MONTGOMERY COUNTY PLANNING DEPARTMENT
THE MARYLAND-NATIONAL CAPITAL PARK AND PLANNING COMMISSION

MEMORANDUM

SUBJECT: Observation Drive Extended Phase I Transportation Facility Planning Study -
Project Prospectus Recommendations

SUBJECT: DEPARTMENT OF PARKS REVIEW OF OBSERVATION DRIVE
EXTENDED: PHASE 1 FACILITY PLANNING STUDY

ALTERNATIVE 4- MASTER PLAN ALIGNMENT ADJUSTED

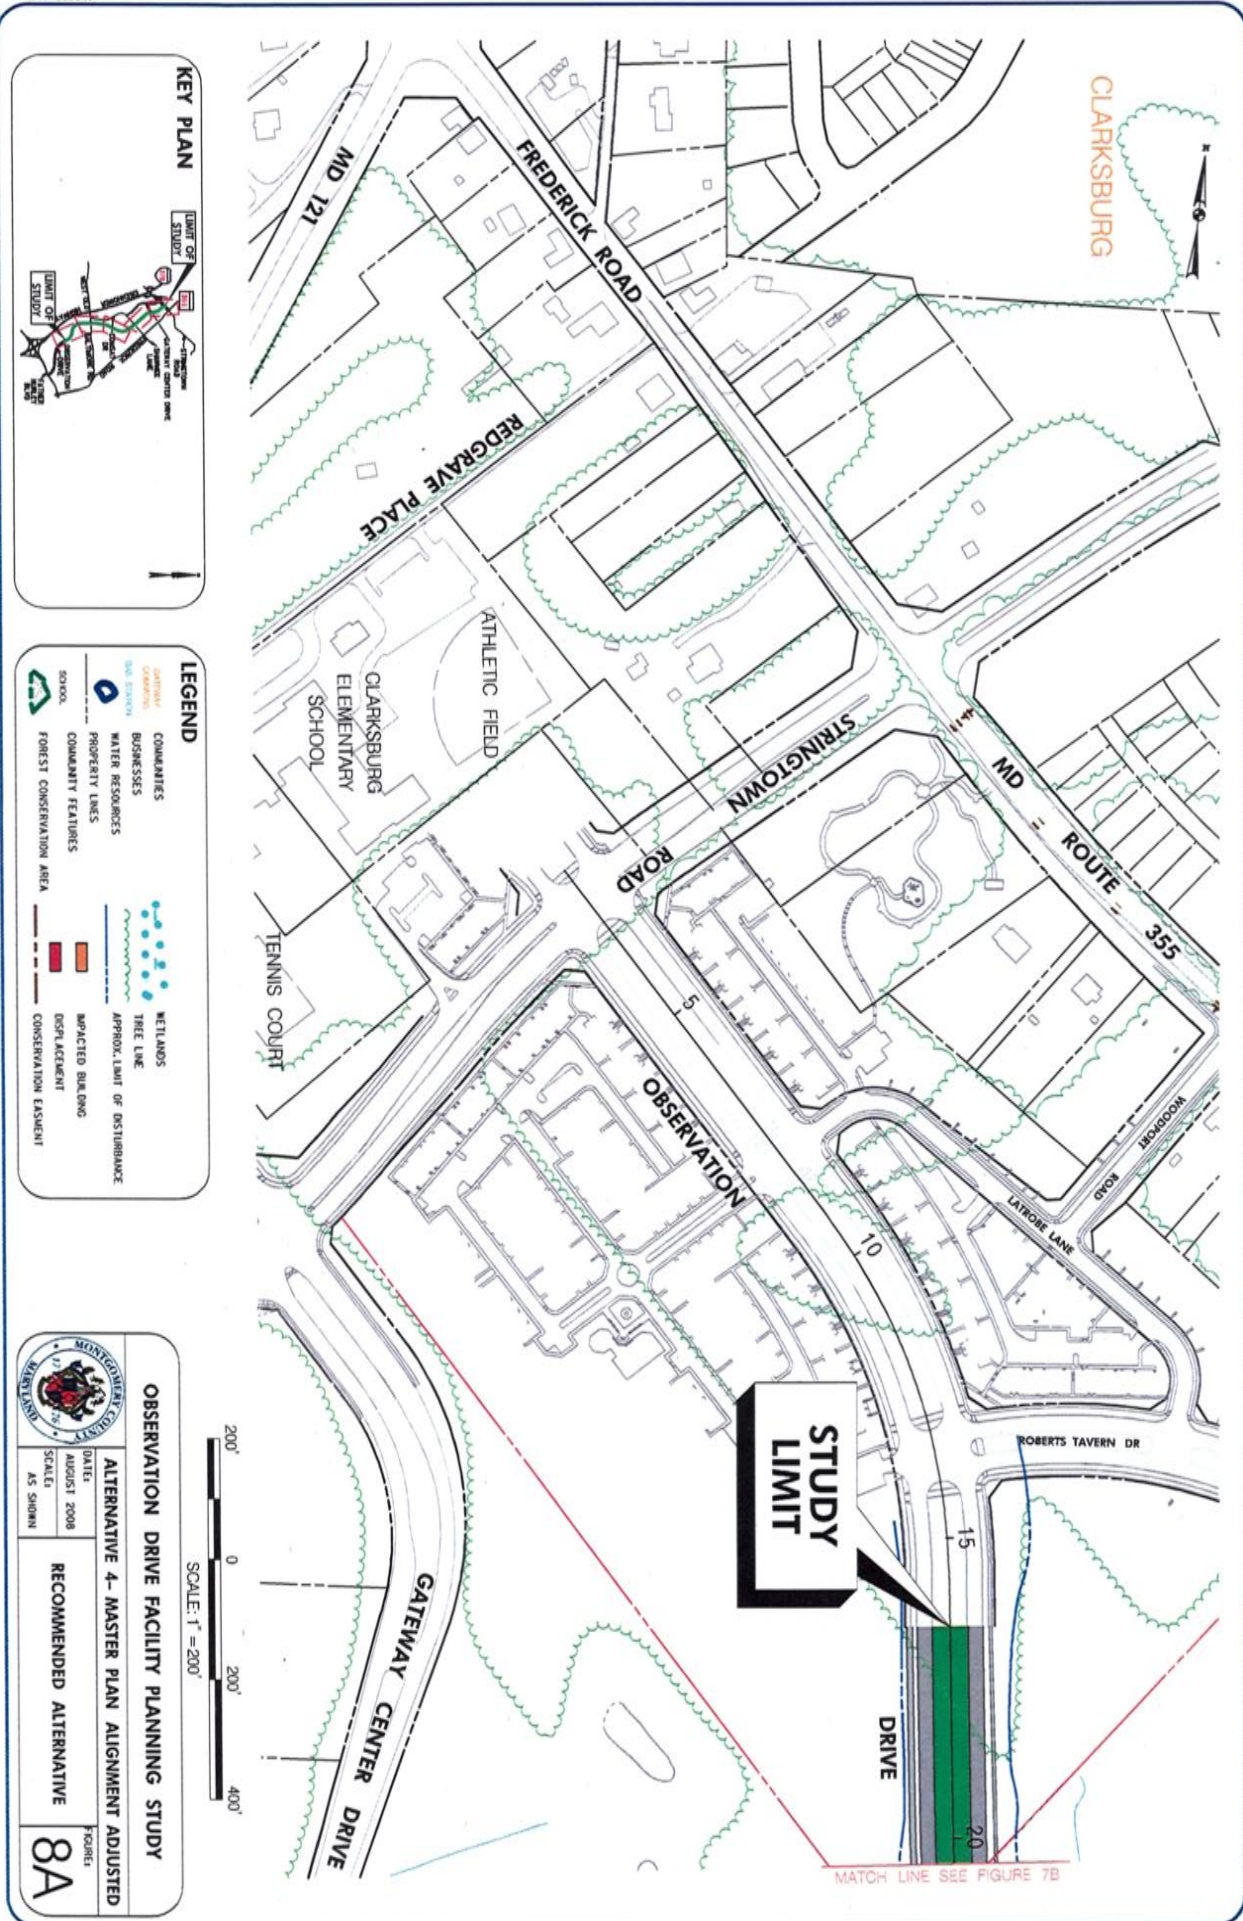
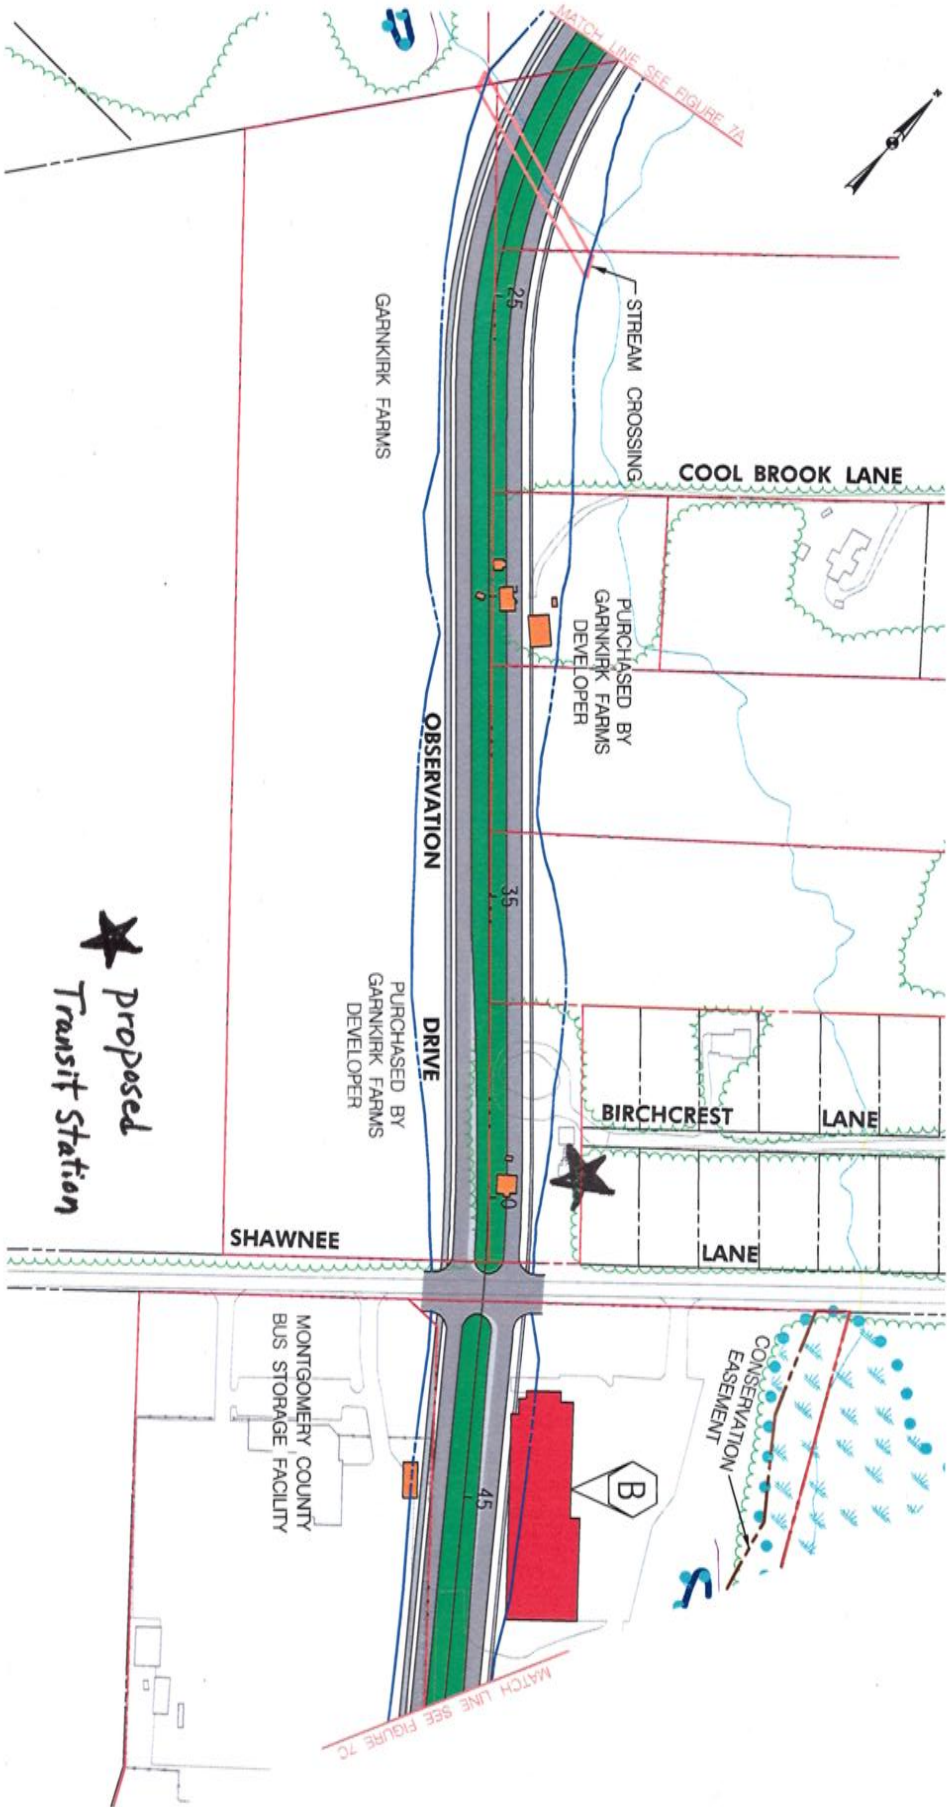
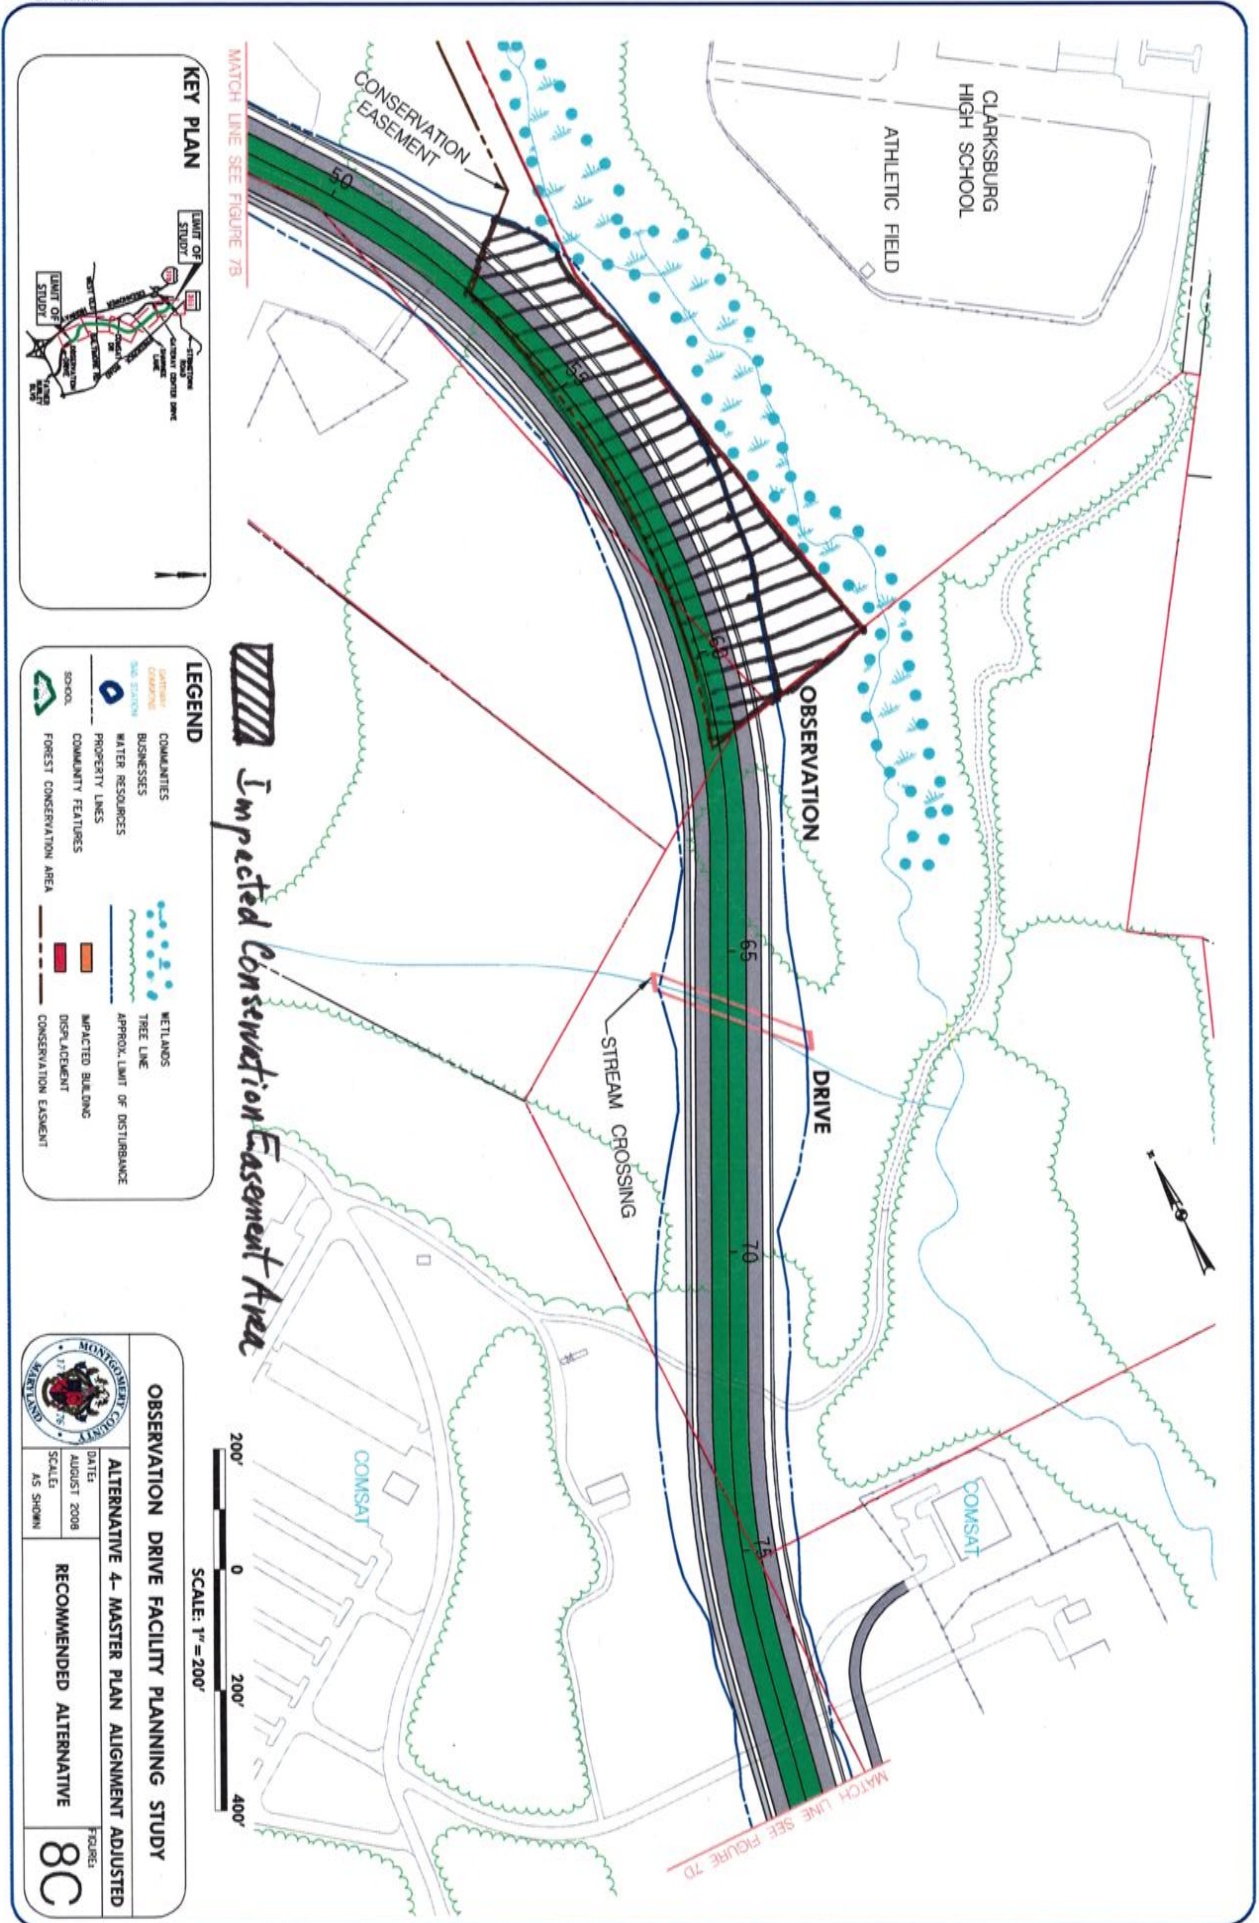
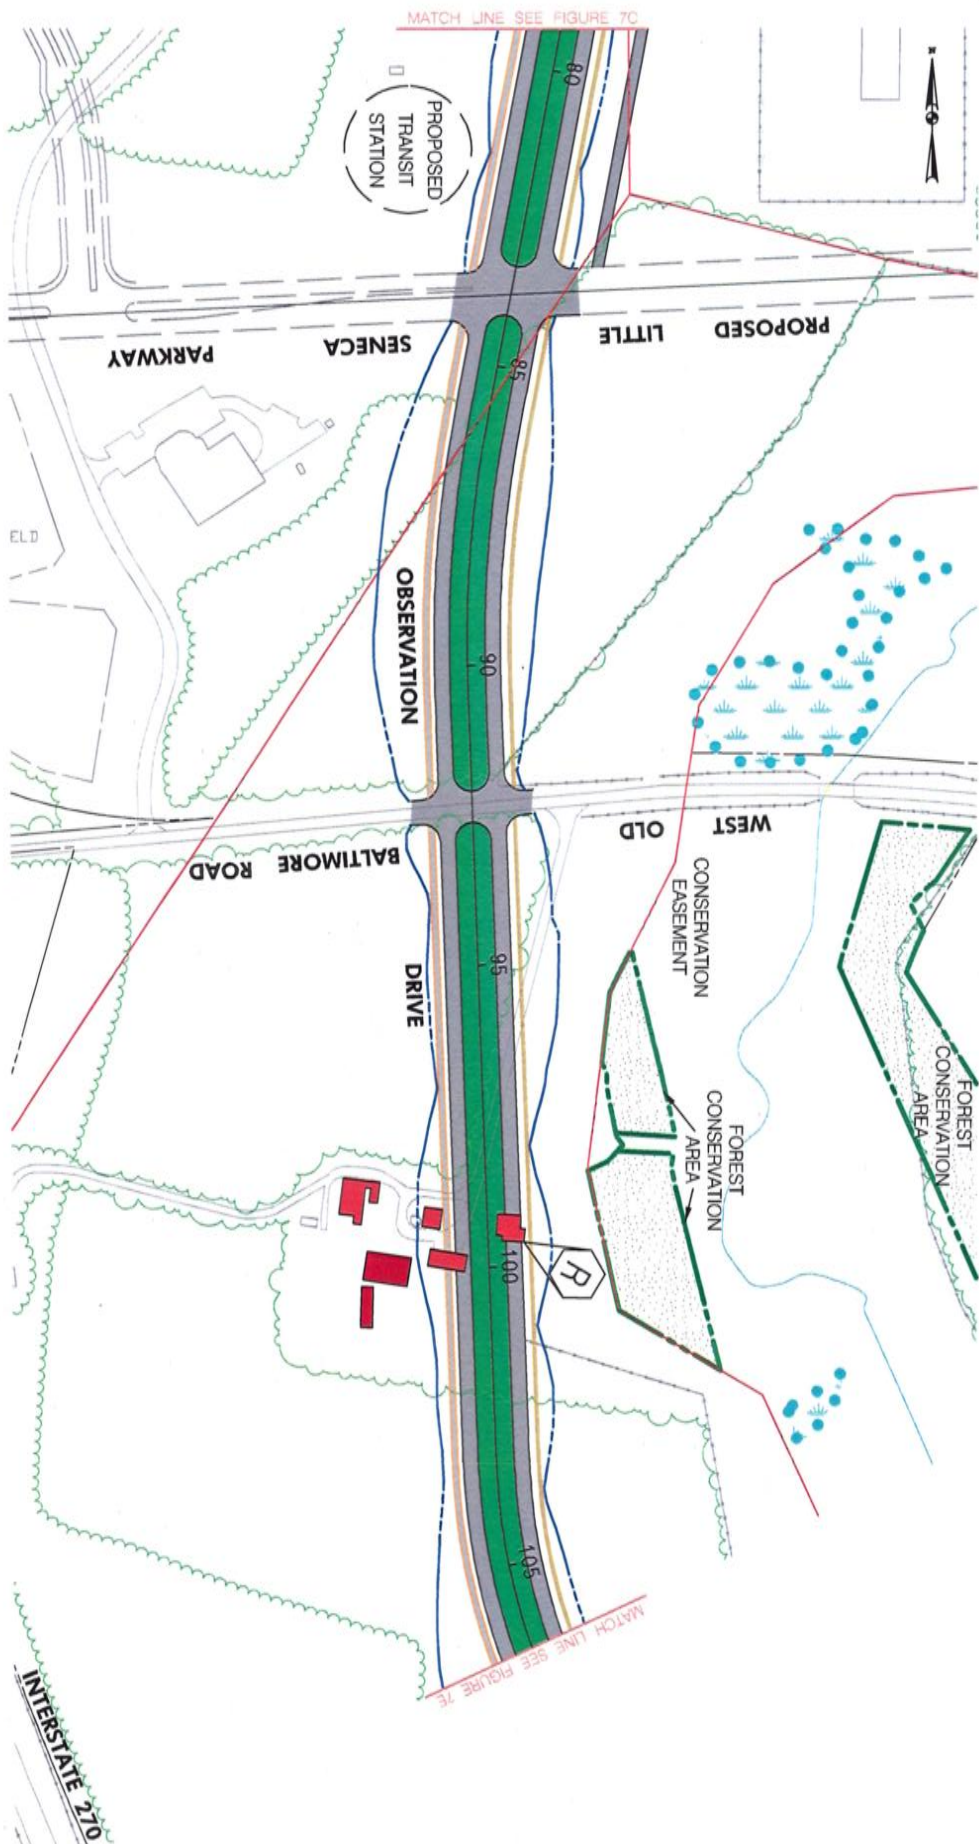
1. The Observation Drive Extended Transportation Facility Planning Study should proceed to Phase II of the Facility Planning process as recommended in the September 2008 Project Prospectus to develop a detailed design for Alternative 4, Master Plan Alignment Adjusted, after including the required horizontal and vertical geometric criteria for light rail transit (LRT) and addressing the comments of the Maryland Transit Administration (MTA).
2. Per the Project Prospectus recommendation, the design for Observation Drive Extended should be a four-lane closed section roadway as recommended in the Germantown and Clarksburg Master Plans.

- b. Consider narrowing the median width to approximately 36 feet outside station areas to reduce impacts in environmentally sensitive areas where station platforms and left turn lanes are not needed.

- f. Include spirals in the roadway horizontal geometry so that LRT can be accommodated without variations in the median offset.
6. During the Phase II Facility Planning study, mitigation strategies for impacted Conservation Easement areas must be identified.

Third, it appears that a 50 mph *roadway* design speed was used for this study rather than a 50 mph rail design speed, which would have required longer, flatter curves both vertically and horizontally, and created more impacts on adjacent properties and environmental resources. It appears that the current design would accommodate only a 27 mph operating speed for LRT along the curves in the Little Seneca Creek Stream Valley.

Given that this project has three stream crossings and impacts wetlands, one Conservation Easement, and North Germantown Greenway Park, strong consideration should be given to using a 36-foot-wide median outside station areas. The Army Corps of Engineers required a similar reduction in the median width of the Montrose Parkway West project as a condition of their permit for the stream crossing on that project. Master planned right-of-way has been established for Observation Drive as it crosses North Germantown Greenway Park. **The effects of a potentially narrower median but wider sidewalks recommended by staff on the bridge over Little Seneca Creek should be examined in Phase II.** We have an MOU with MCDOT that addresses how any park impacts of master planned roadways should be addressed. The project also impacts a 1.6-acre Conservation Easement on the Moyer and Sons property. This Conservation Easement predates both the 1991 Forest Conservation Law and the establishment of the Observation Drive alignment in the 1994 Clarksburg Master Plan. During Phase II mitigation strategies for impacted Conservation Easement areas must be identified.
